We have reviewed the proposed s4.55 amendments to The Pittwater House Schools project, against both the stormwater and overland flow designs approved with DA2019/1274.

Stormwater

Overland flow

Figure 1. Stormwater that would have fallen on the roof will be collected in a linear drain

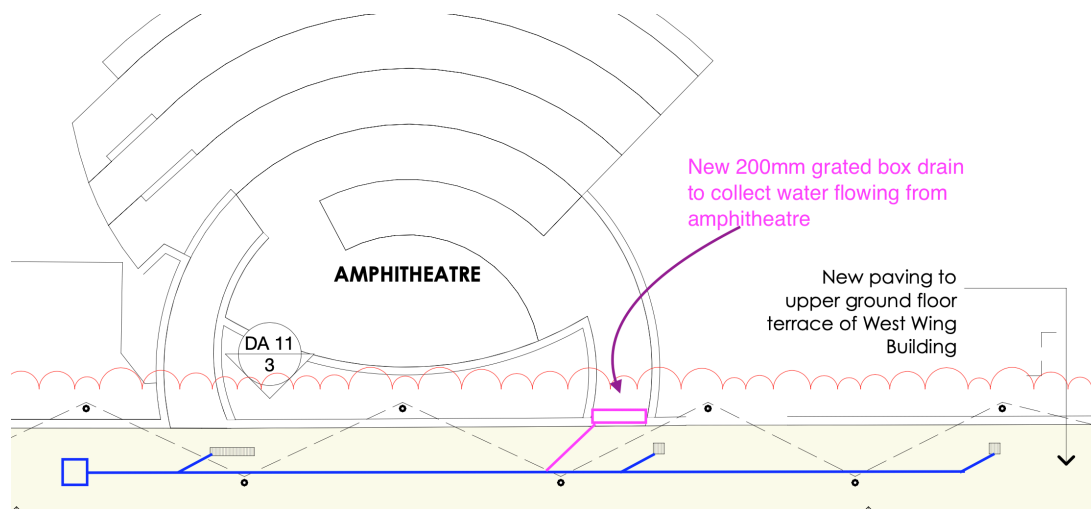
The amendments include removal of the existing amphitheatre roof shown on architectural drawing DA05. The stormwater falling on the existing amphitheatre roof collects via a system of gutters and downpipes to a central pit and discharges into the stormwater conveyance pipes.

Once the roof is removed and replaced with shade sails, the stormwater will fall into the amphitheatre and collect at the walkway entrance shown in Figure 1. The new stormwater will be collected in a conventional 200mm grated box drain and connected to the existing stormwater conveyance pipe.

There will be no net change to stormwater flows offsite as a result of the s4.55 amendment.

Figure 2 Predevelopment 1%AEP flow

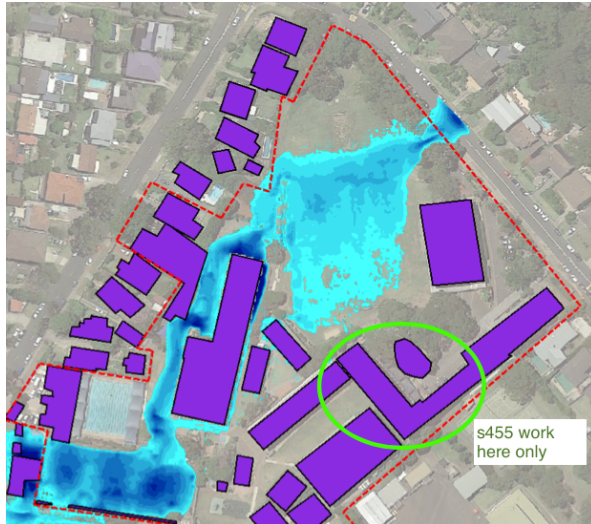
Figure 2 shows it is clear of the 1%AEP overland flow.

Figure 3. Predevelopment PMF flow

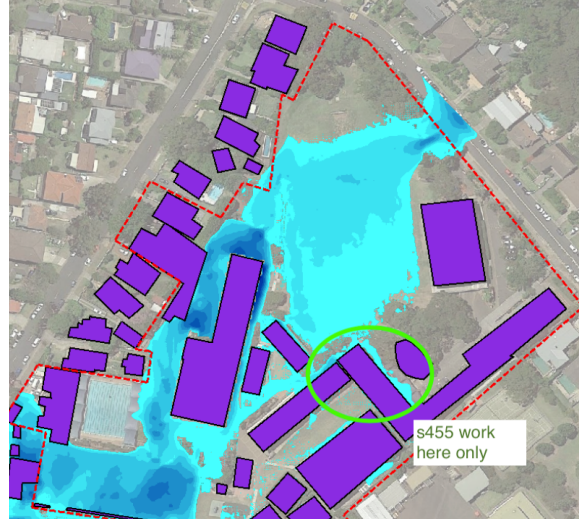
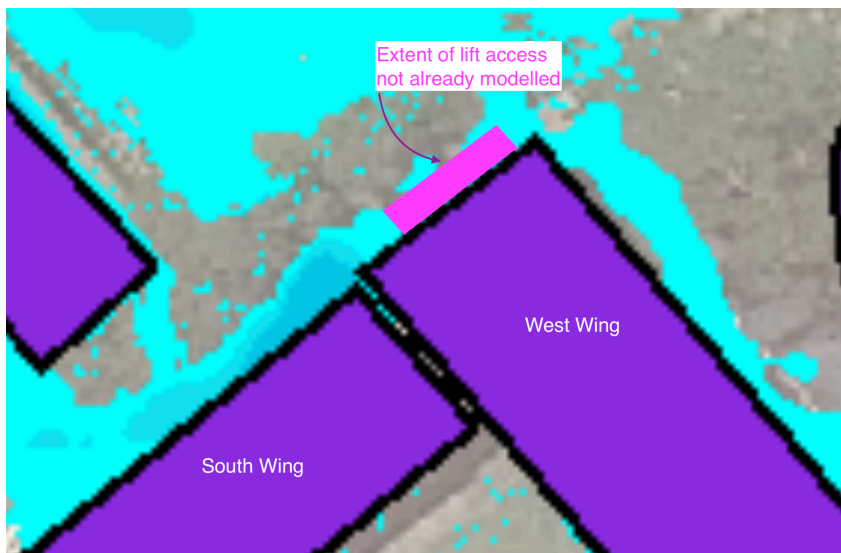
The construction of the flood bund on the oval (described in our report P170688-RP-FL-001 dated 25 October 2019) will be completed during Stage 2 of the project. This means a temporary situation where the predevelopment PMF flows (shown in Figure 3) remain and interact with the Stage 1 works (shown in this s4.55 amendment).

Figure 5. New layout around canteen area, including new lift and access platform

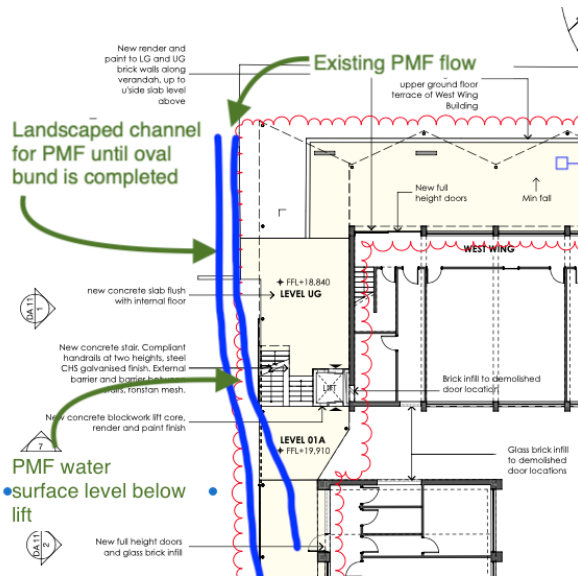
The key s4.55 amendment relevant to overland flow—adjustment of the lift access area—is shown in Figure 5.

Like the original proposal, a new lift and associated widening of the access area at Level UG is proposed. For the temporary arrangement, the PMF flow arriving from the oval will be diverted via a 150mm hob—either an extension of the retaining wall or a landscaped mound—along a dedicated landscaped channel section before re-joining its pre-development flow path along the western side of the South Wing building.

Figure 6. Hob shown in magenta diverting flow through landscaping to re-join original flow path

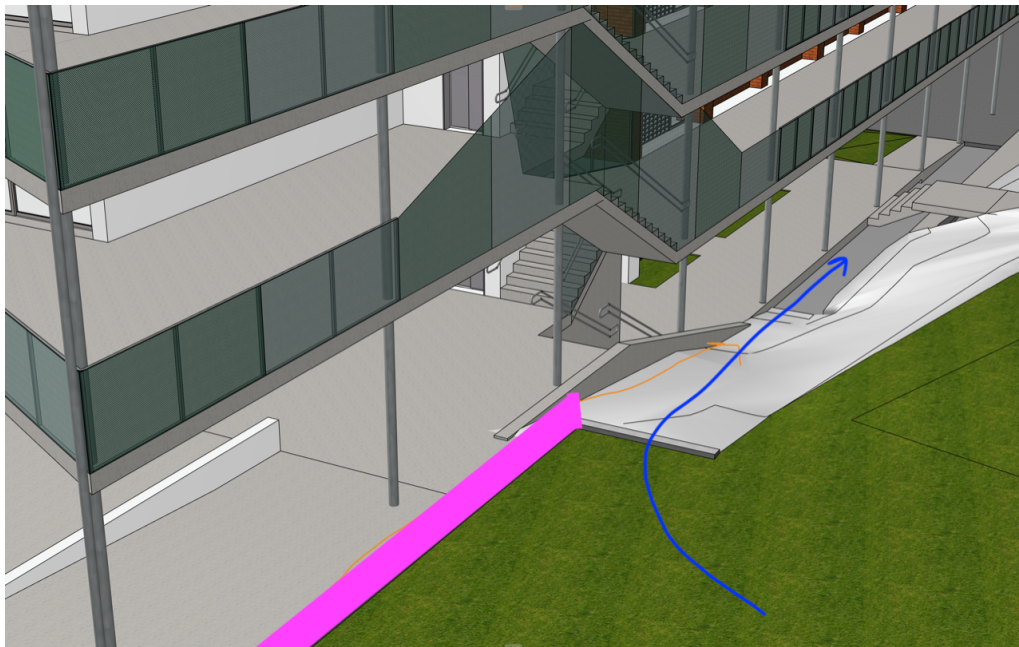
The lift entry point at RL18.84 is approximately 1.2m above the PMF water surface level (where 150mm deep water flows along ground surface at RL17.5). The entry point is also protected by the bund.

Once Stage 2 is completed, the temporary bund becomes redundant and can be removed.
